**SEQUOYAH NUCLEAR PLANT - ACCEPTED VERSION OF TOPICAL REPORT  
NO. 24370-TR-C-001-A, "ALTERNATE REBAR SPLICE - BAR-LOCK  
MECHANICAL SPLICES"**

PROJECT Sequoyah DISCIPLINE N  
CONTRACT 99N5B-253631 UNIT 1  
DESC. Topical Report - Mechanical Rebar Coupler Qual.  
DWG/DOC NO. 24370-TR-C-001-A  
SHEET - OF - REV. 00  
DATE 04/28/03 ECN/DCN - FILE N2N-059

**SEQUOYAH UNIT 1**

SUBJECT: SEQUOYAH NUCLEAR PLANT, UNIT 1, SAFETY EVALUATION OF TOPICAL  
REPORT NO. 24370-TR-C-001, "ALTERNATE REBAR SPLICE - BAR-LOCK  
MECHANICAL SPLICES" (TAC NO. MB5371)

Figure 3. Bar-Lock Coupler Cutaway View Showing Internal Details

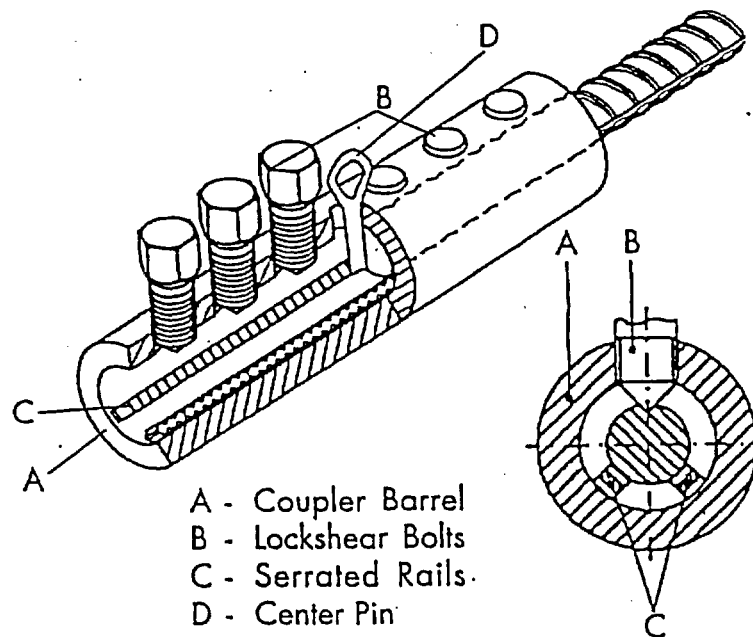
The Bar-Lock coupler system relies on the clamping force generated on the rebars between the lockshear bolts and serrated rails. Provide the magnitude of the compressive stress and force on the tip of a lockshear bolt and the strain in the bolt after the bolt installation. Provide the stress relaxation characteristic of the lockshear bolt (relaxation is defined as the loss of its compressive stress under strain for a period of time). Provide evidence that the clamping force generated by the lockshear bolt would not be reduced, as a result of the relaxation phenomenon, to a point that would degrade the proper function of the Bar-Lock coupler system during the life of the plant.

The Bar-Lock bolt tips are hardened to a level that exceed the hardness of the rebar, ensuring no plastic deformation of the bolt tips. The results of the testing performed at SQN confirmed this design, in that where the splice failure mode was rebar pull-out, the rebar had been damaged by the bolt tips, while no bolt tip failures were experienced. Note that the splice failure occurred well after the design load was reached. To show that the design properly accounts for the stress and strain is evidenced in the reliability of the couplers tested in this qualification process.
